Information Request

EFSB-MED-1

Please refer to Exhibit 7, the Host Community Agreement between Exelon and the Town of Medway.

RE: Air Quality Regulatory Review of the Proposed Exelon Expansion

Figure 1: Historic Demands and Permit Limits (MGD), Town of Medway

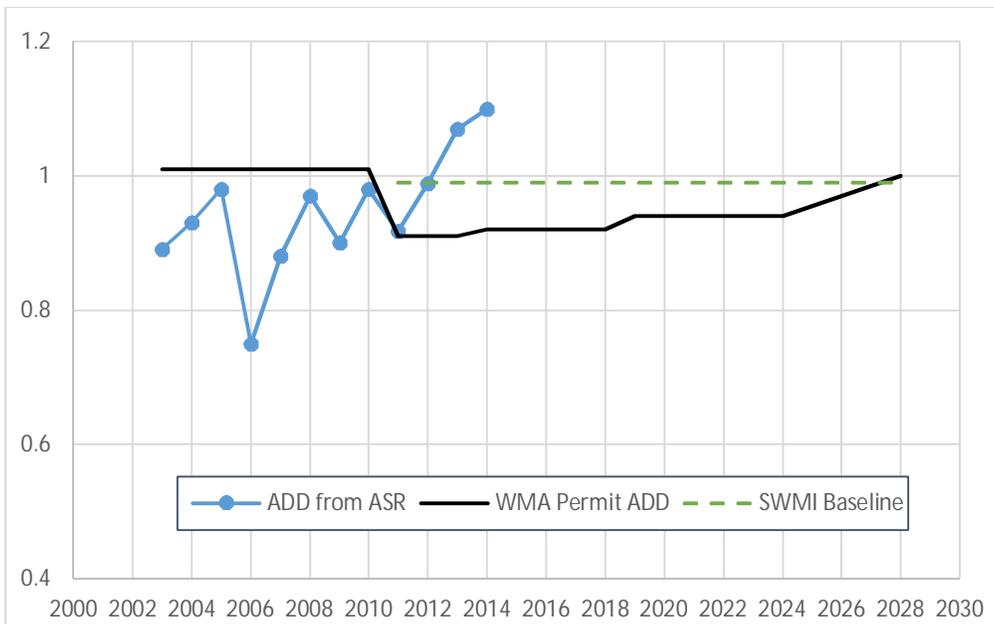
Based on Figure 1, ADD has been trending upward since 2006, despite a number of actions taken by the Town to reduce demand (discussed in further detail in Section 3). Unaccounted for water (UAW) has also been rising during this interval. In response, the Town has increased its leak detection survey frequency from annually to biannually starting in 2013. Between November 2014 and December 2014, the Town of Medway contracted a vendor to perform a correlation leak detection survey of the Town's entire water distribution system (Liston, 2014). The previous leak detection survey in 2013 (Thurber Assoc.) detected 50 gpm of leakage. The total leakage based on the 2014 survey was estimated at 360 gpm (0.52 MGD), including a large 300 gpm water main leak on Village Street near Walker Street. The Town of Medway repaired the water main break

The sharp rise in demand may be attributable to leakage. The leak repair made in December 2014 has reduced daily demand as exhibited in the daily pumping records maintained by the Town. Figure 2 below shows daily production and consumption from January 1, 2014 through June 24, 2015, with the leak repair of December 2014 effectively dropping the daily production rate from around 1.2 MGD to less than 0.8 MGD for the winter months. Therefore, the water demand (ADD and MDD) for the Town of Medway is expected to be lower for 2015 than in previous years.

Figure 2: Decrease in Pumping Following Repair of 300 gpm +/- Leak in 2014

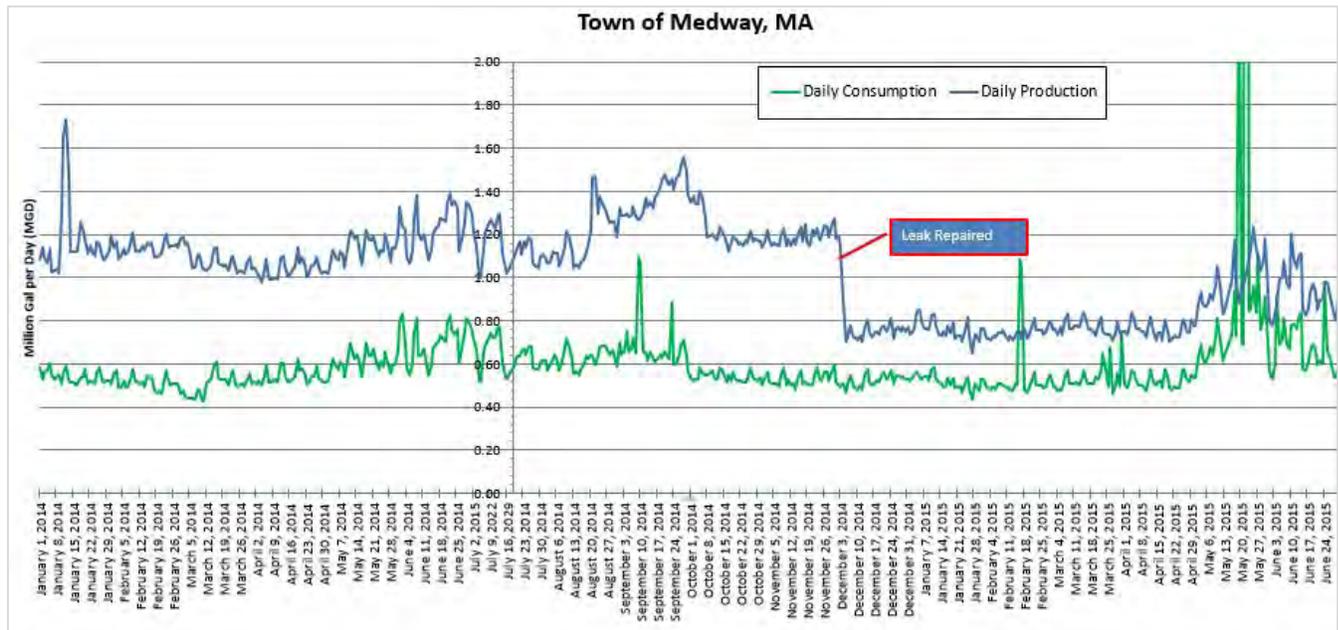
In order to estimate current ADD and MDD values for 2015, Kleinfelder utilized the Town’s average production value for the year 2015 to date, from January 1st to August 25th (Holder, 2015b). Based on this information, the estimated ADD value for 2015 is 0.86 MGD. While this ADD value is assumed to be representative of the current Town of Medway water system, it is noted that the value accounts for the high-demand summer season yet not the fall and early winter when demands tend to decrease. As such, it is anticipated that the Town’s final ADD for 2015 might actually decrease below 0.86 MGD. However, since this is speculative, the ADD of 0.86 MGD was viewed as a more conservative figure and it has been utilized for evaluation purposes in this report.

Figure 3: Historic and Projected ADD Compared with Supply and Permit Limits (MGD), Town of Medway

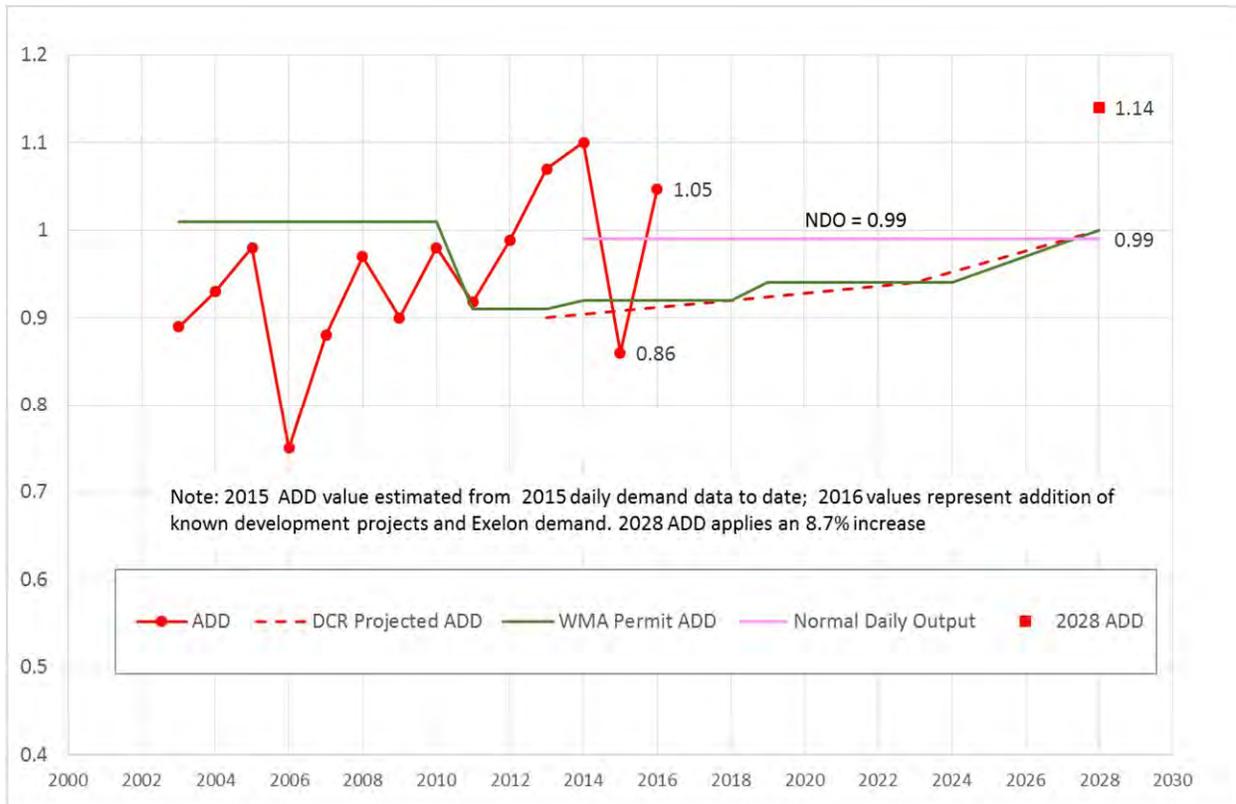
Figure 3 graphically summarizes Medway's supply in comparison with average day demand. Permit limits are also presented for reference.

The system adequacy evaluation has been based on estimated normal and maximum daily output capacities of the wells as reported by Medway (Table 2-2). As seen on Figure 3, assuming normal daily output (NDO) rates, without the Oakland Street Well running, Medway's supply availability (0.99MGD) to meet 2016 projected (including development and Exelon) ADD of 1.05 and future ADD of 1.14 is not adequate. **There is a supply deficit of 0.06 MGD in the near term, and a future deficit of 0.15 MGD for meeting ADD.**

Figure 4: Historic and Projected MDD Compared with Supply and Permit Limits (MGD), Town of Medway

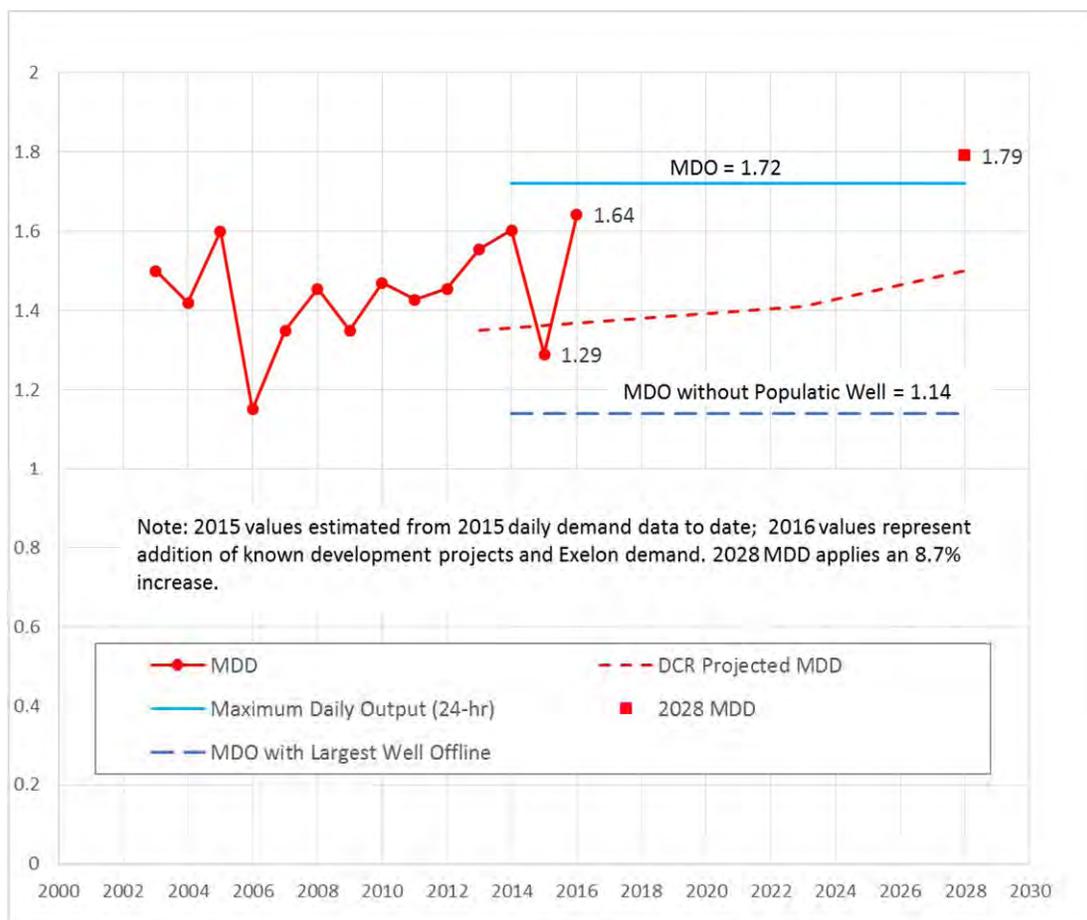
Figure 4 below illustrates Medway’s supply in comparison to MDD. Assuming maximum daily output (MDO) rates for 24 hours per day, using all four of their wells running, Medway’s supply availability (1.72 MGD) to meet estimated 2016 (including development and Exelon) MDD of 1.65 is adequate. **However, it is insufficient to meet future MDD of 1.79 MGD.** Note that this assumes the pumping of the Oakland Street Well, which has high levels of iron and manganese. Medway is in the process of developing a corrective action plan to address manganese in order to meet new MassDEP health advisory for manganese. In the interim, Medway may have to provide public notification regarding high levels of manganese and potential health effects when Oakland Street Well is pumped in order to meet MDD.

In the case for the Town of Medway, the single, largest source is the Populatic Street well, because it has the highest permitted withdrawal volume as well as the highest pumping rate (0.58 MGD pumping at 24 hr/day). With the Populatic Street well offline, the available maximum daily output from the Town of Medway system is reduced from 1.72 MGD to 1.14 MGD. **Therefore, with the Populatic Street well offline the Town of Medway cannot meet its current or future MDD. There is a current supply deficit under this scenario of 0.46 MGD.**
